Oregon State University
Construction Contract Administration
ITB 198995 – OSU SOFTBALL FIELD CONVERSION

ADDENDUM NO. 1

**OREGON STATE UNIVERSITY
 SOFTBALL FIELD
 CONVERSION**

F-1.4

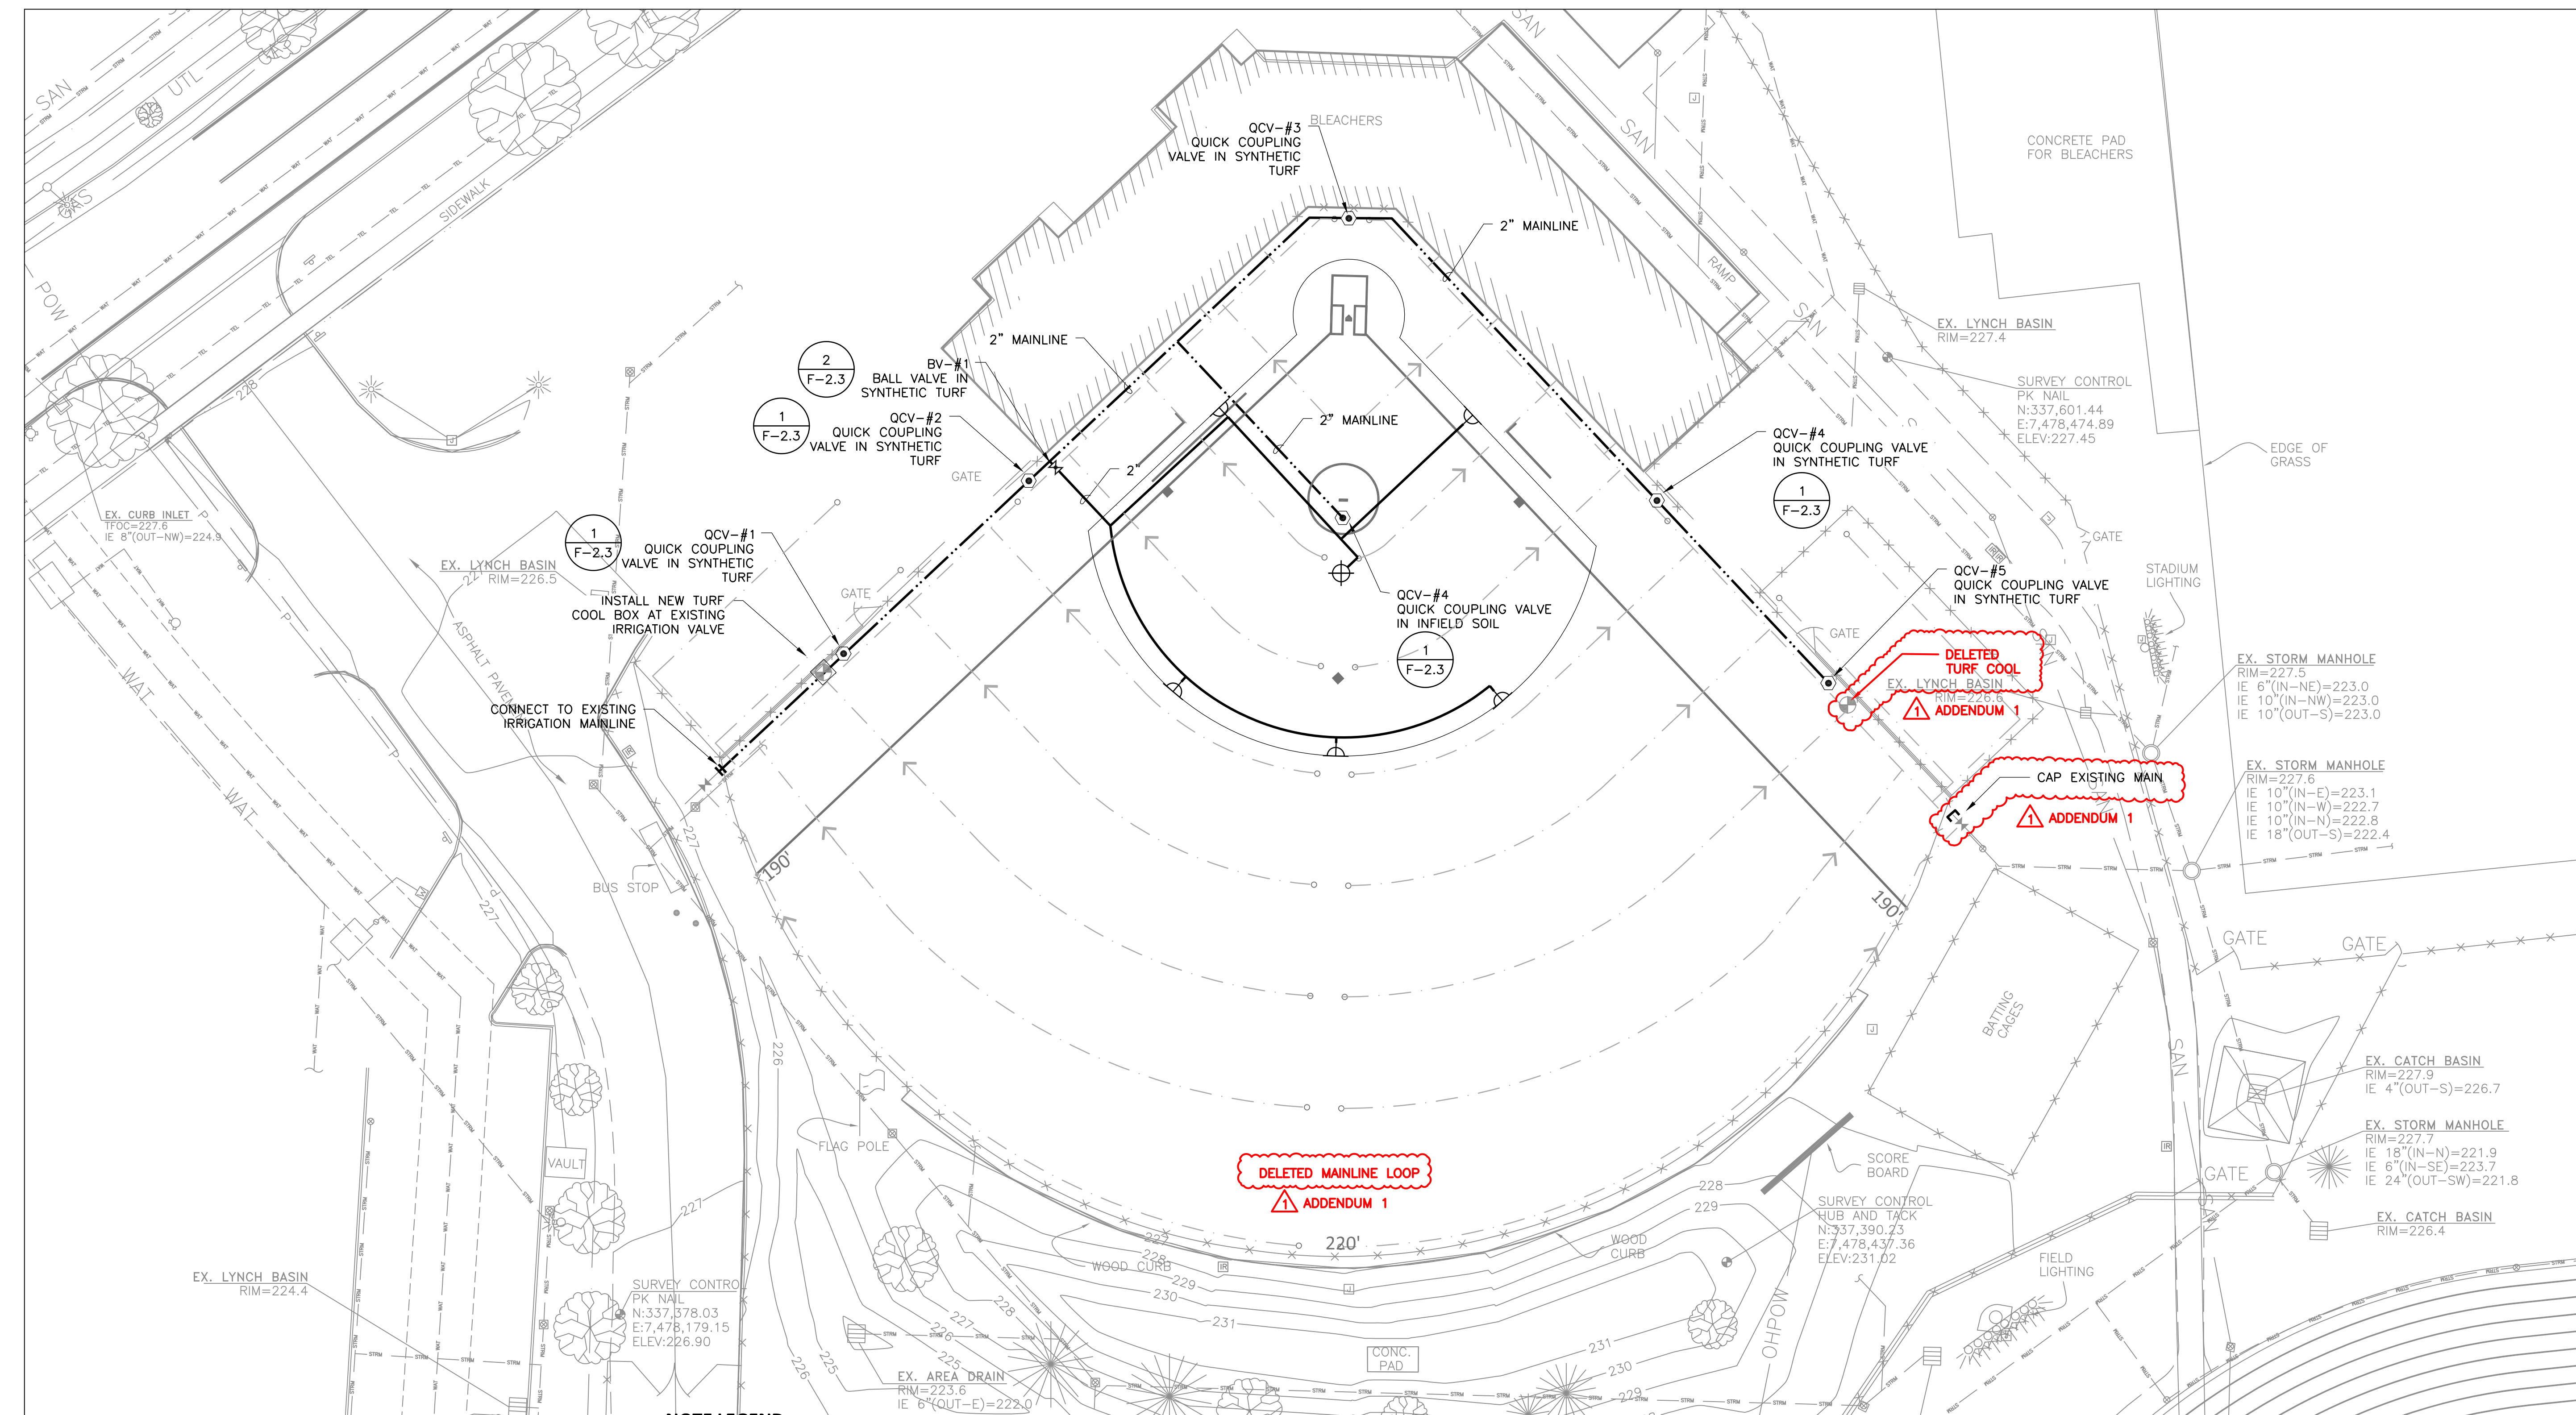
Deleted reference to one (1) Turf Cool Box at existing mainline valve, added capping of existing mainline at one location, and eliminated new mainline "loop" segment along the outfield perimeter.

2 SOFTBALL HOMEPLATE AND PITCHER'S CIRCLE
 F-2.4 NOT TO SCALE

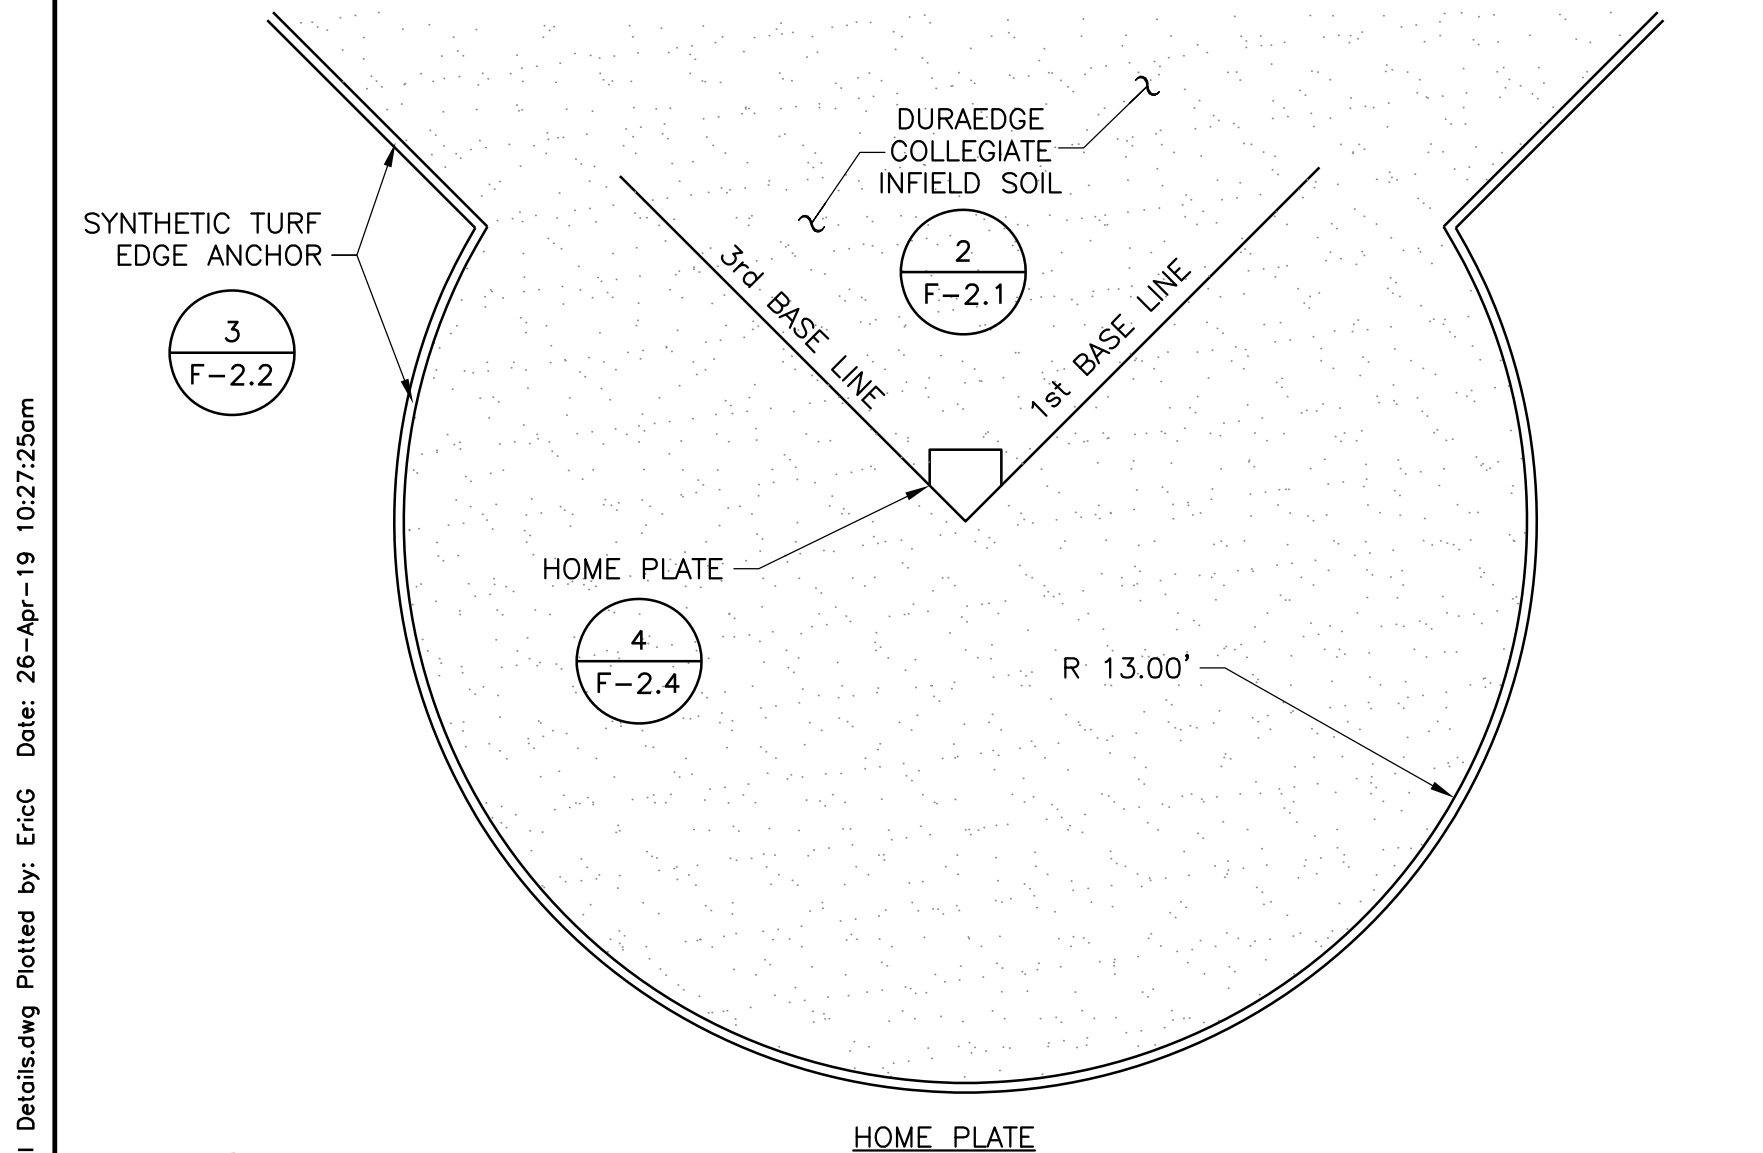
ADDED Clay Reinforcing to 2/F2.4 Pitching Lane and 5/F2.4 Batters' and Catcher's Boxes.
